# Content

1. Background
2. ICCT proposal: noise and health issues
3. Standardization work – ISO5130
4. ECE regulations and the way forward

# 1. Background

Figure 7. Relationship between average annoyance and personal noise exposure expressed as maximum noise level in 5 dB(A) classes.

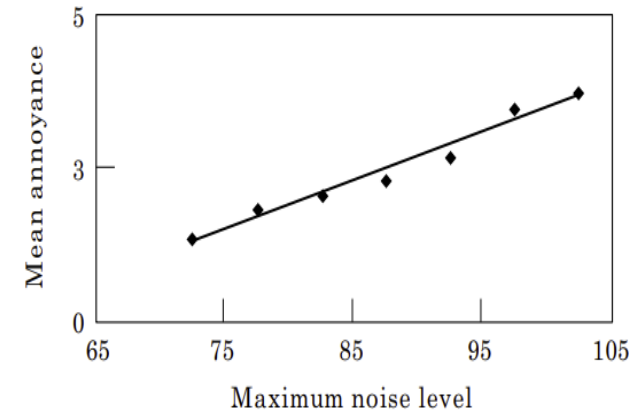
## L<sub>Amax</sub> and annoyance, ICCT and reference to SATO et al, 1999:

A limit of 95 dBA at 0.5 m: Annoyance Scale = 3  
Point source: 83 dB at 2 m ~ 2.5 on the scale  
and 71.5 dBA at 7.5 m: 2=Notice –not annoyed
